TECH NOTES

Date: 7-3-07

Re: Replacing 500-Note with 700-Note Bill Acceptors in Aurora Games

FIGURE 1 – AURORA REAR DOOR FROM THE INSIDE

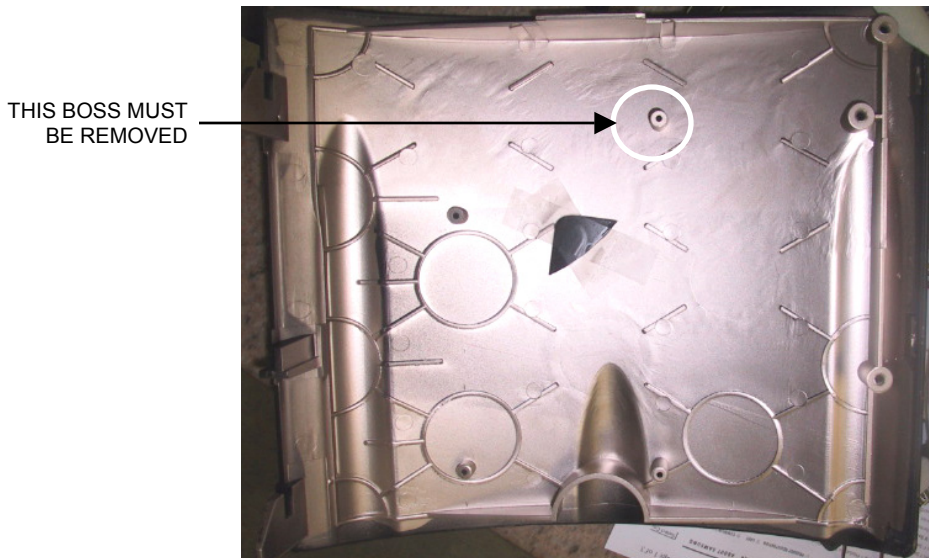
If your Aurora game has a 500-note bill acceptor, you may replace it with your own 700-note stacker, if desired. To do so, you must have a rear door with one of the bosses on the door removed (see Figure 1).

If your door does not already have the specified boss removed, then you may carefully remove it, making sure not to damage the plastic or finish in the surrounding area.

After installing the 700-note stacker, you will also have to remove the locking cash bracket and not reinstall it. Although each cash bracket has a different key, all Aurora games built with a 500-note stacker and the locking cash bracket, have the same key for the rear door, so it may be beneficial to change the lock on your game.
